## *Firmware Release Notes*

# **ControlLogix SynchLink Module**

Catalog Number 1756-SYNCH

Publication 1756-RN579C-EN-P - December 2002

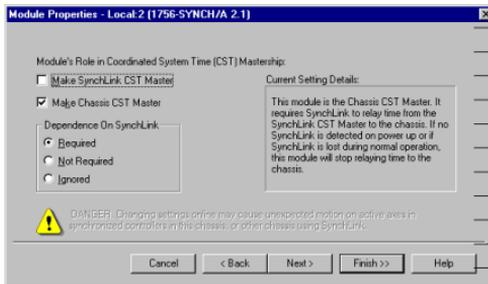
### **Some Module Configuration Changes Can be Made While Online with RSLogix 5000**

You can change any configuration options shown on the Time Mastership tab while the module is online.

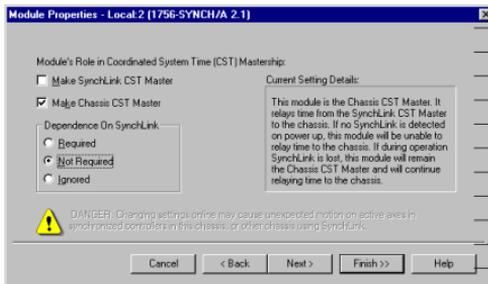
- The module stops relaying time to the chassis. In this case, the chassis is unsynchronized once communications are lost. The software settings for this option are shown below.

The previous module revision (i.e. 1.17) only offered this option when communications with the CST master are lost.

With this setting, there must be a connection with the CST master when the 1756-SYNCH module powers-up. If there is no connection, the module faults and has no CST time until the connection is made the CST master.

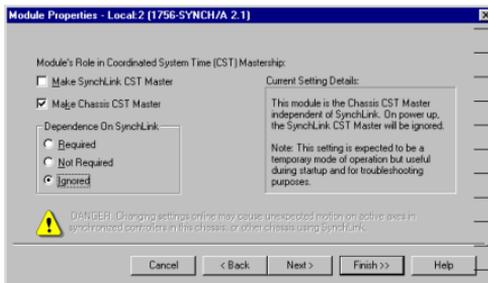
- The module continues to relay time and acts as Chassis CST Master. In this case, you must be aware that this chassis is running unsynchronized motion and you must account for the setting in your application's logic. If communications are resumed over the fiber optic cable, you must do the following to become synchronized with the CST master:
  - Stop all motion connected to this chassis.
  - Reset the 1756-SYNCH module to time relay function

The software settings for this option are shown below.

The CST does not start in this chassis until a connection is made with the CST master, typically at module power-up. If there is no connection to the CST master at power-up, the module faults and has no CST until the connection is made.
